RE: Sheldon Museum, Middlebury, VT

Re: Request for Variance under Section 1-4.4 (NFPA 101-1988)
and Section 513.1 Special Historic Buildings and Districts (BOCA NBC-1987)

Reference: Sheldon Museum Addition, Middlebury, VT

Reference: Sheldon Museum renovation and addition.

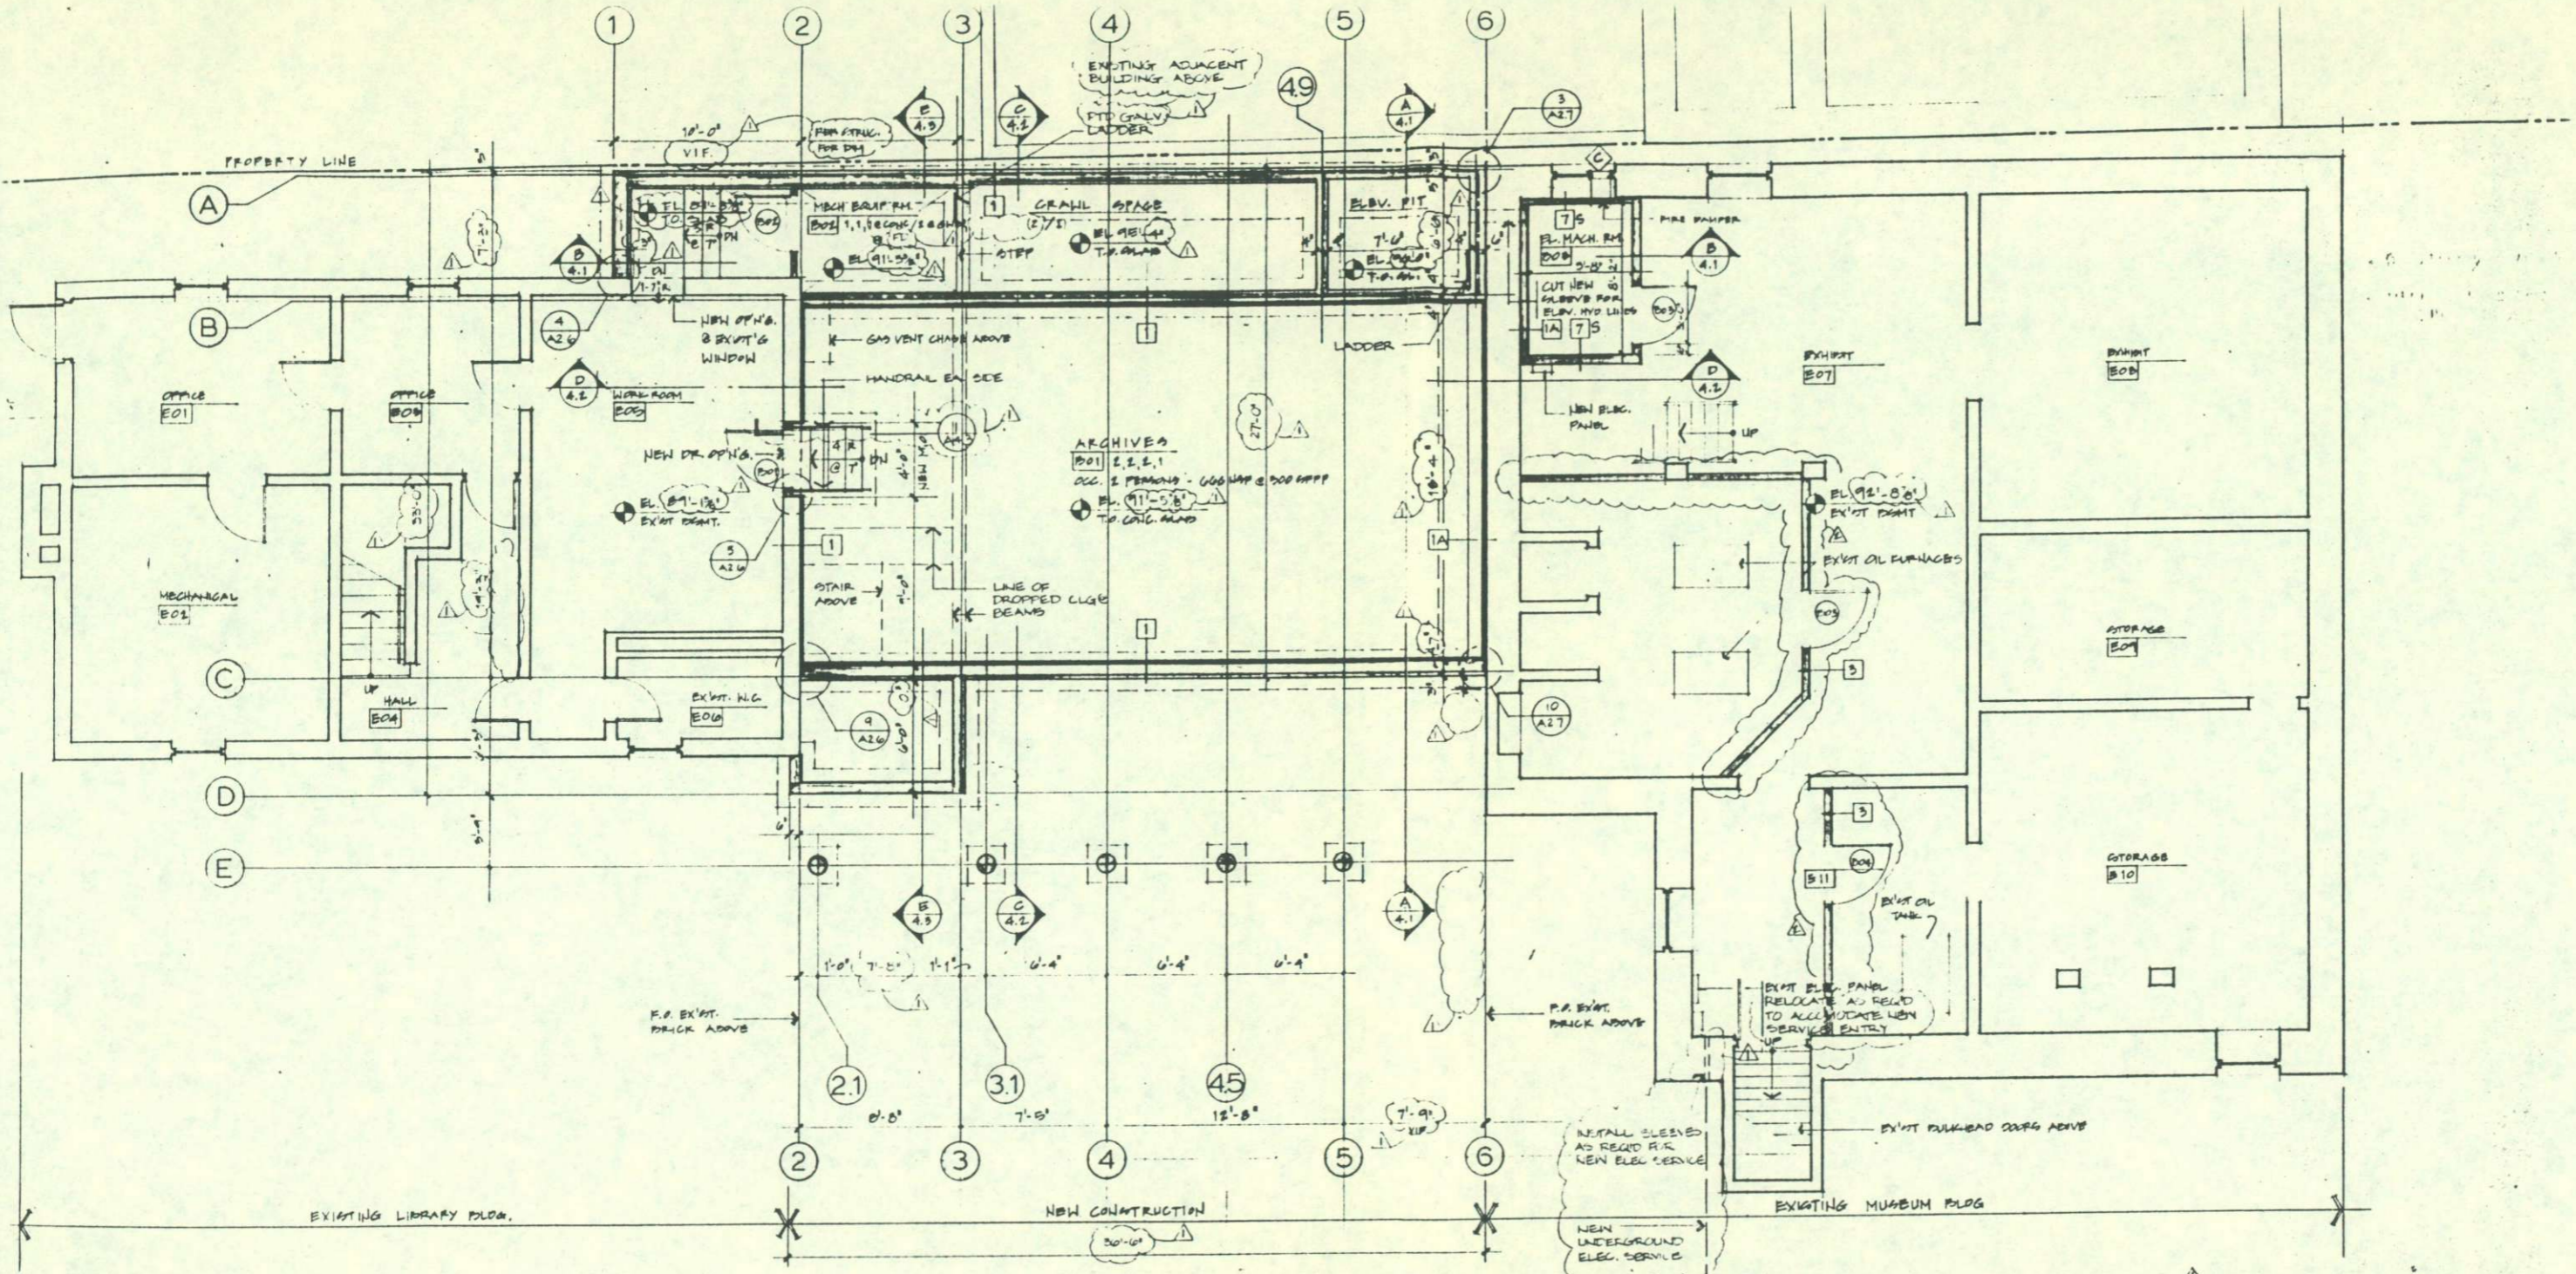
7. If the basement is to be used as an area of display as associated with the museum then the entire basement must be sprinklered. Otherwise the HVAC rooms and the storage rooms must be sprinklered or enclosed in a one hour fire resistive enclosure.

One hour enclosures will be constructed as shown on the attached plans (Dwg. A 2.1)
